CHANGE ORDER No. 03Date of Issuance: 5/9/2025

Project Name: 2025 Street Maintenance Pavement & Curb Repairs	Owner: City of Bel Aire	Owner's Project Number:
Engineer's Project Number (if applicable): 31-237363-013-2564	Date of Contract: 3/26/2025	
Contractor: APAC Kansas Inc., Shears Division	Funding Agency Project Number (if applicable):

OWNER: CITY OF BEL AIRE
 PROJECT: 2025 STREET MAINTENANCE IMPROVEMENTS
 DATE: MAY 2025

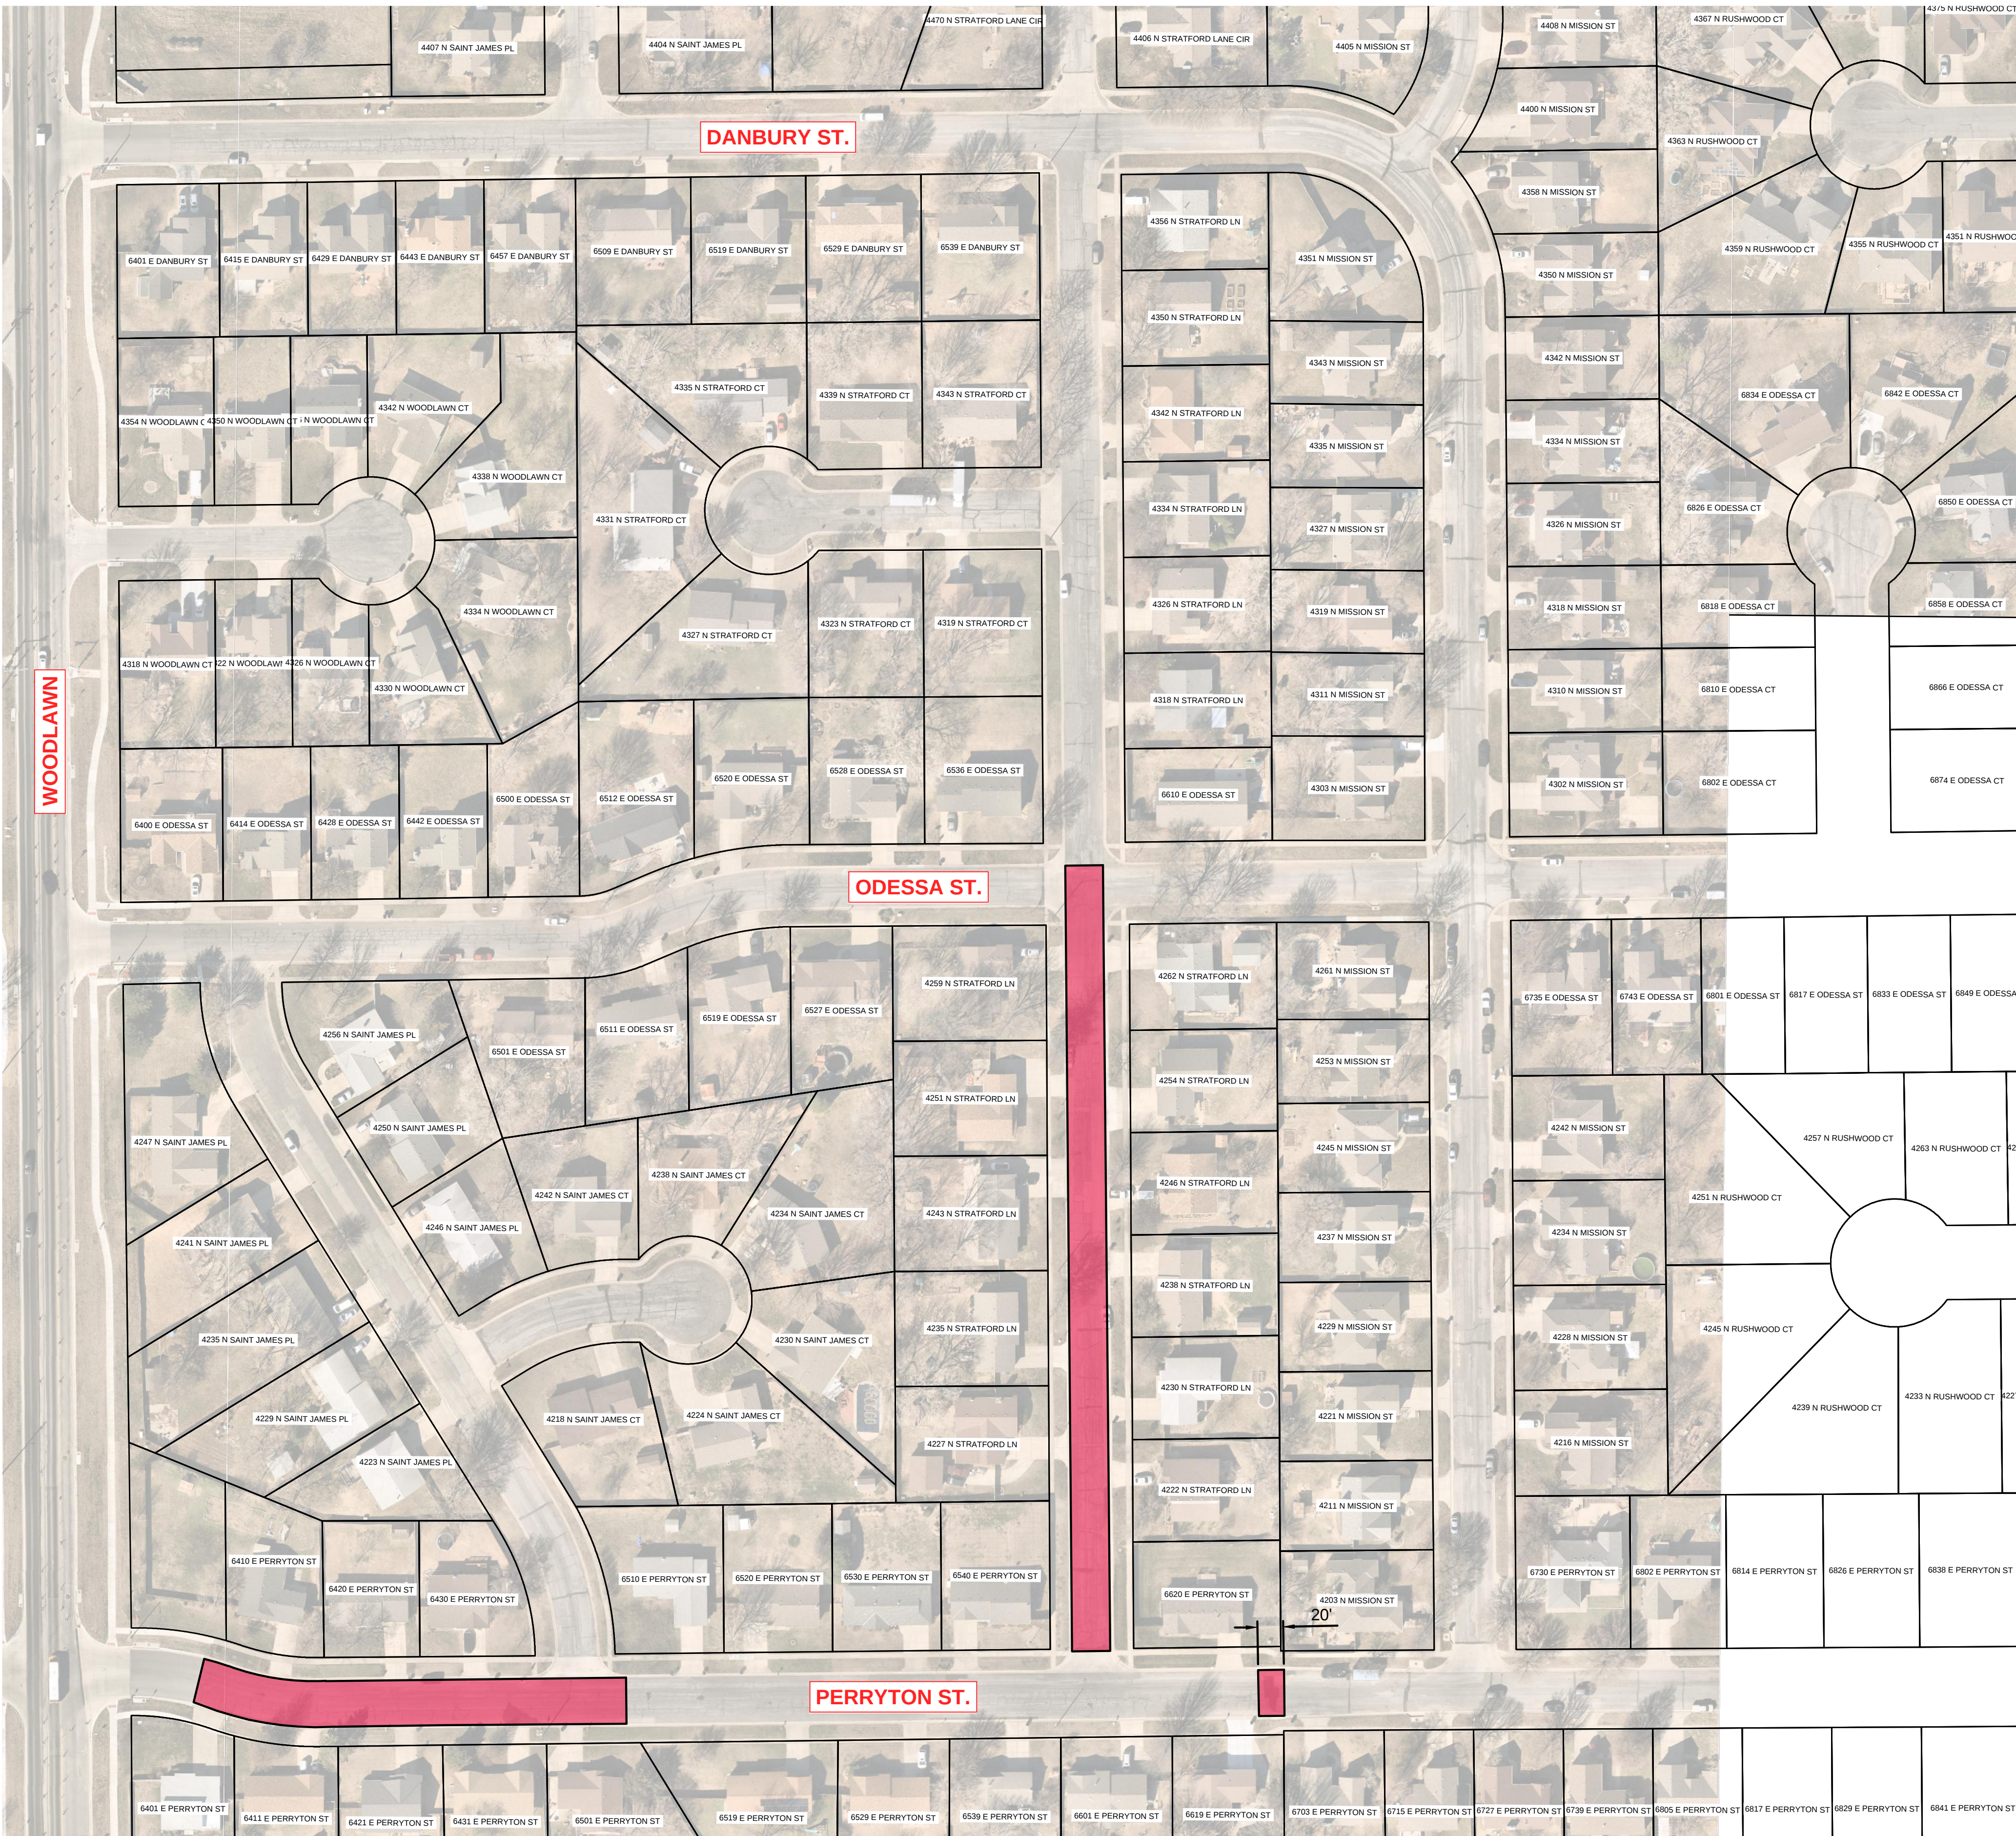
Soft spots and poor subgrade discovered during the milling process. Additional work as described
Justification: in the attached documents. No additional contract time.

ITEM NO.	DESCRIPTION	QUANTITY	UNIT	ENGINEER'S OPINION OF PROBABLE COST	
				UNIT PRICE	COST
STRATFORD LANE - ODESSA TO PERRYTON					
1	Pavement Removal	2,028	SY	\$ 5.00	\$ 10,140.00
2	Full Depth Asphalt Repair (6")	2,028	SY	\$ 28.00	\$ 56,784.00
3	Crushed Rock Base (5" Reinforced)	2,028	SY	\$ 10.00	\$ 20,280.00
4	A.C. Surface Course, 2" (BM-2) (PG 64-22)	-220	TONS	\$ 74.00	\$ (16,280.00)
SUBTOTAL				\$	70,924.00

1	Pavement Removal	1,418	SY	\$ 5.00	\$ 7,090.00
2	Full Depth Asphalt Repair (6")	1,418	SY	\$ 28.00	\$ 39,704.00
3	Crushed Rock Base (5" Reinforced)	1,418	SY	\$ 10.00	\$ 14,180.00
4	A.C. Surface Course, 2" (BM-2) (PG 64-22)	-154	TONS	\$ 74.00	\$ (11,396.00)
SUBTOTAL				\$	49,578.00
